**Building Code of Australia**

**Design Compliance Report**

**REF Level Design Review**

**New High School at Leppington and Denham Court at 128-134 Rickard Rd,  
Leppington NSW 2179**

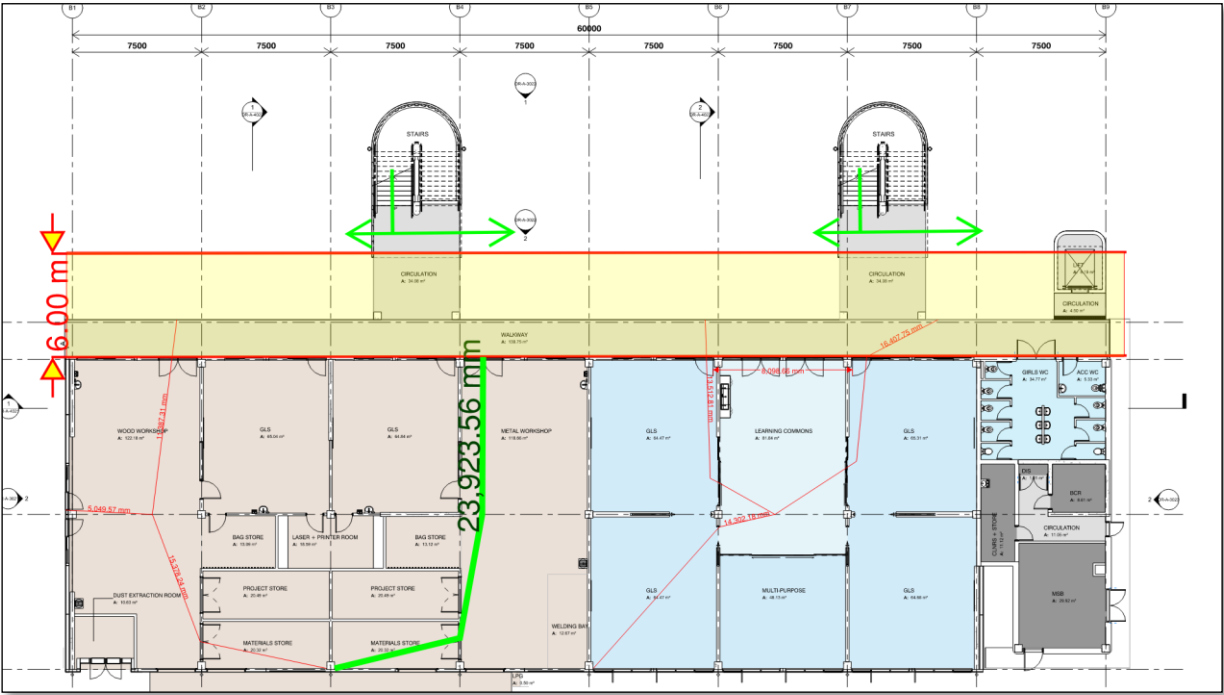
- **Building A – Level 1 & 2** – Egress travel distance exceeds more than 20 (Approx 32m) to a point of choice

**Fire Engineering**

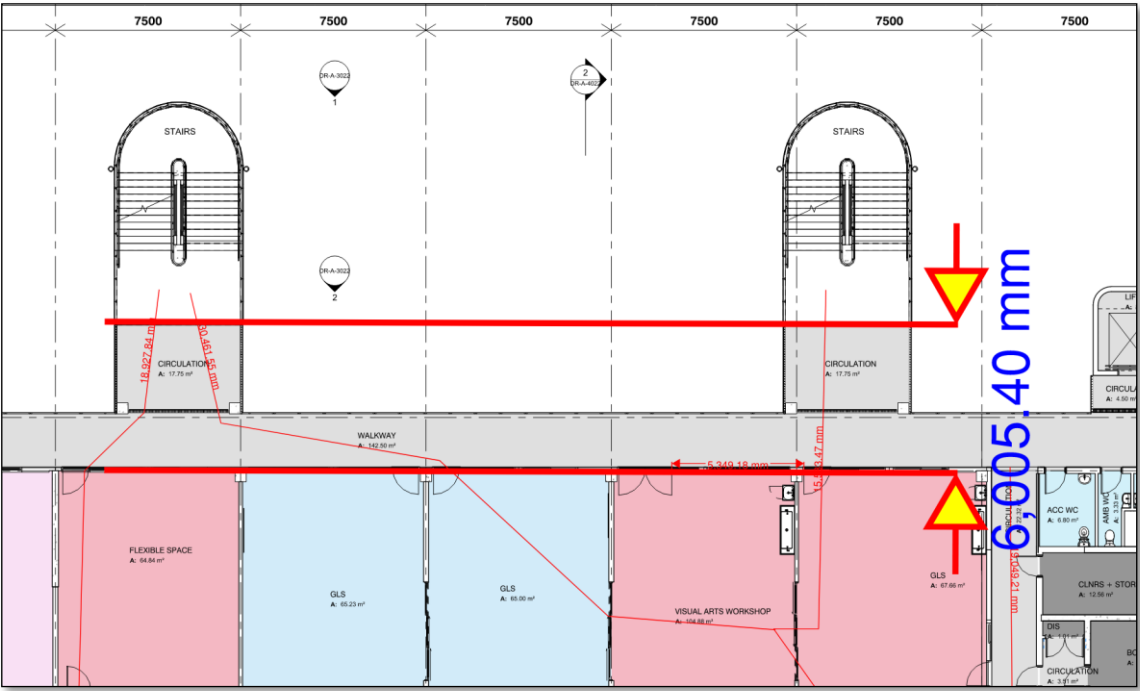
- **Building C – Level 1 & 2** – Egress travel distance exceeds more than 20 (25m) to a point of choice
